Route 44

Transit-Plus Multimodal Corridor

Fall 2019 Outreach Summary

NW Market St from Tallman Ave to 15th Ave NW

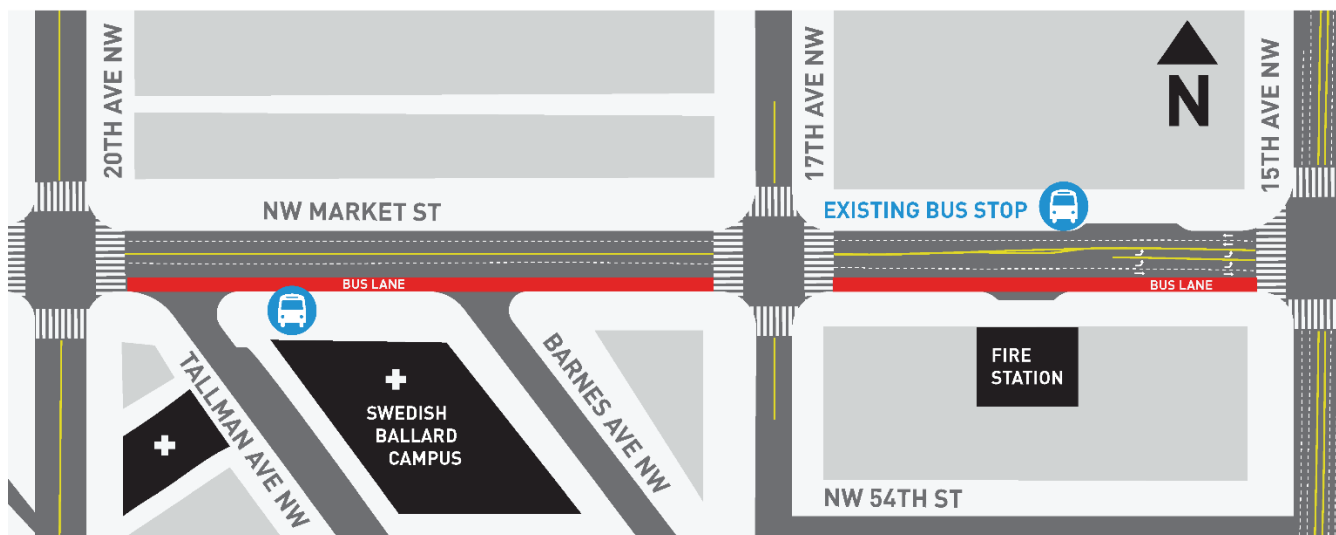
What we heard: There was a large amount of support for eastbound bus-only lanes; however, several people pointed out that this option creates potential challenges for right turns onto intersecting streets. There is also interest in adding a crosswalk along other stretches of NW Market, especially at 11th Ave NW.

N 46th St between Phinney Ave N and SR 99: Eastbound bus-only lane

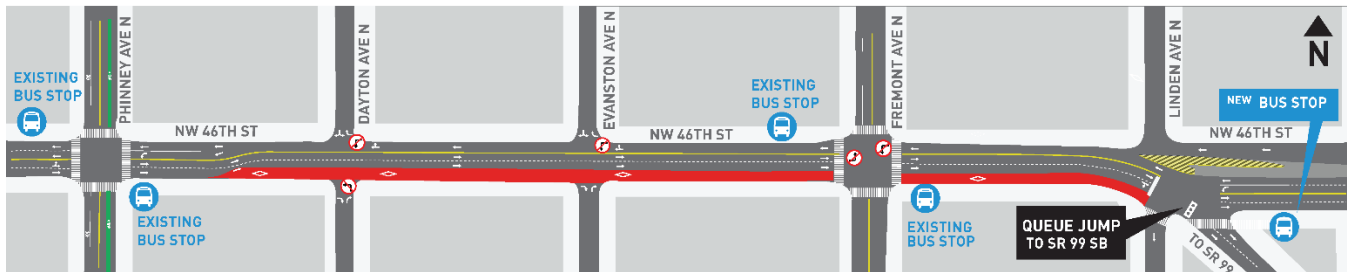
What we heard: Dedicated bus-only lanes were popular with most attendees, but several people had concerns about the left-turn restrictions, which could have the unintended impact of increasing traffic on neighborhood streets.

N 46th St between Phinney Ave N and SR 99: Two-way left-turn lane

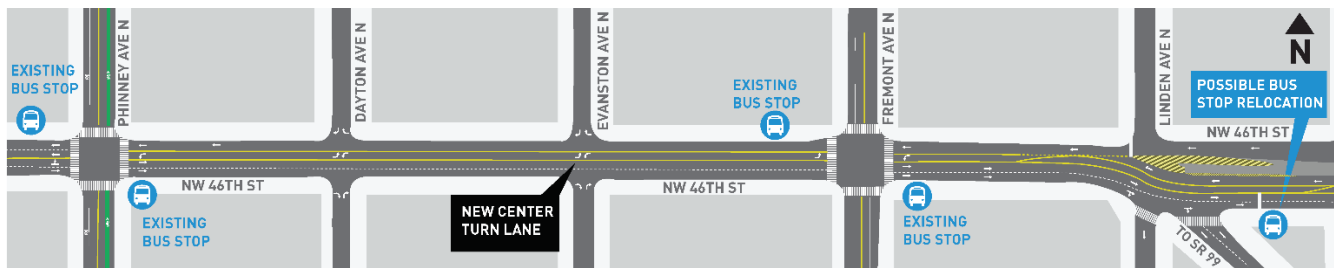
What we heard: There is strong support for improving transit time; however, some residents raised questions about whether the left-turn only lane will improve transit time, and whether it would negatively affect pedestrian safety.

N 46th St and Green Lake Way N

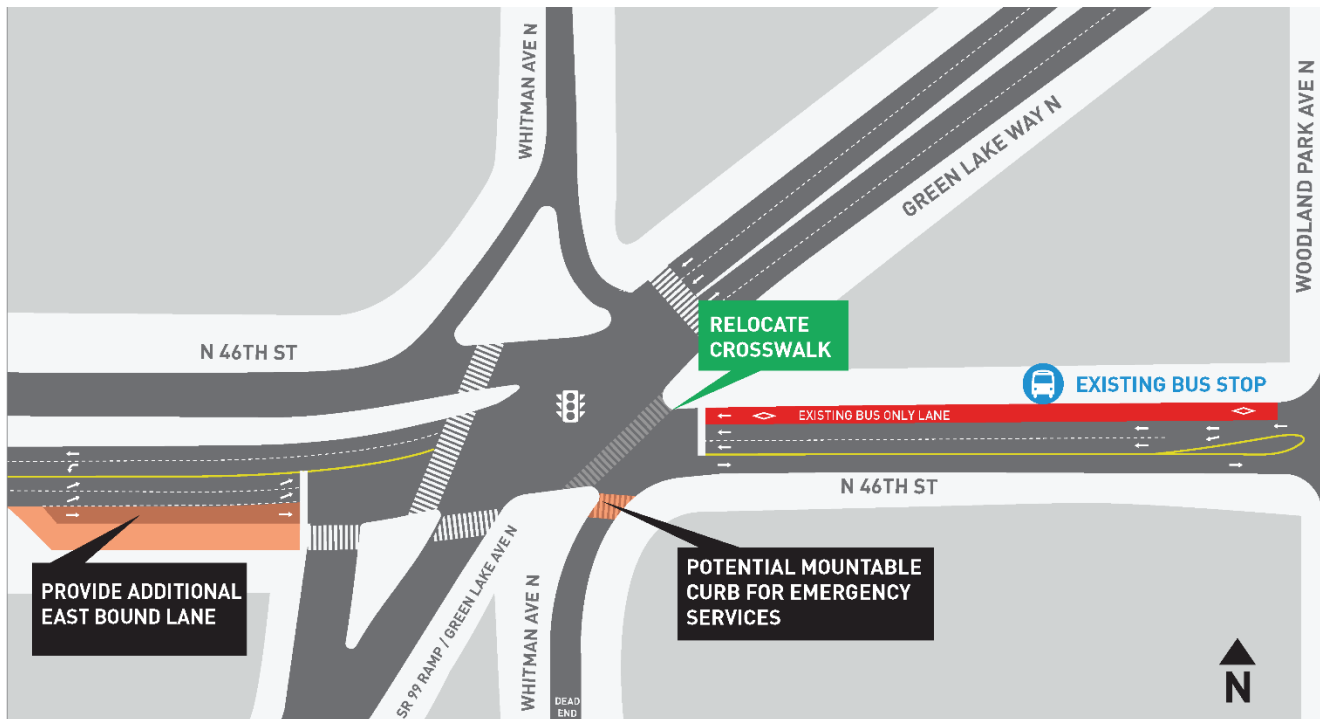
What we heard: Most residents were supportive of shortening pedestrian crossings. However, others were concerned about the potential of reducing right turns onto eastbound 46th, noting that this can cause traffic to back up onto SR-99.

Wallingford Ave and N 45th St

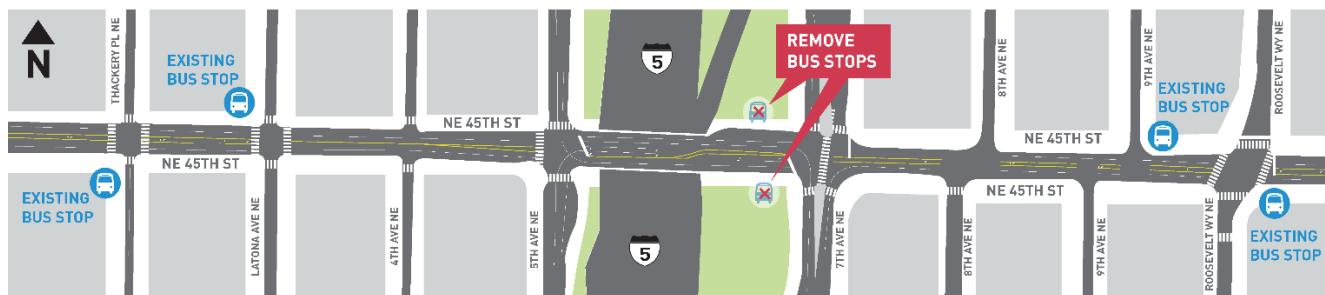
What we heard: Many attendees liked the idea of closing Wallingford Ave to create a new public space, but they were also concerned that this could increase traffic on residential streets or limit freight access to businesses.

Several people also noted that they'd like to see more pedestrian safety measures in this area, including a pedestrian scramble, which allows pedestrians to cross in any direction while all vehicle traffic is stopped.

NE 45th St between 12th and 15th Ave NE

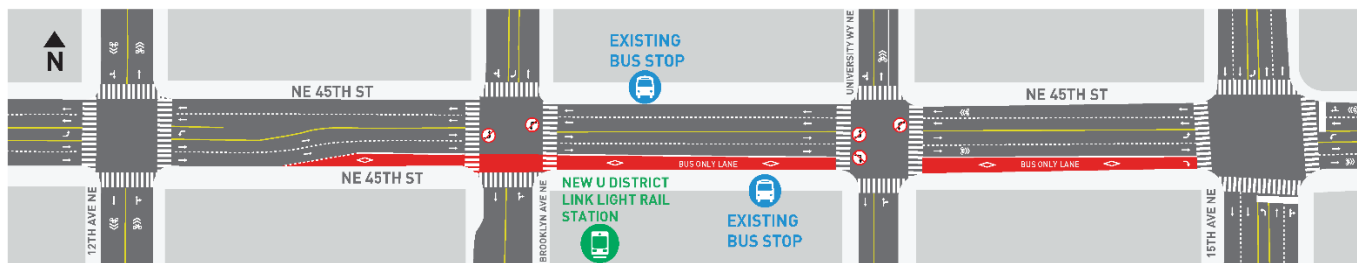
What we heard: There was strong support for adding bus-only lanes in the eastbound direction, and several attendees suggested that we consider adding a westbound bus-only lane. However, some attendees raised questions about the ability of buses to make a right turn onto 15th Ave NE.
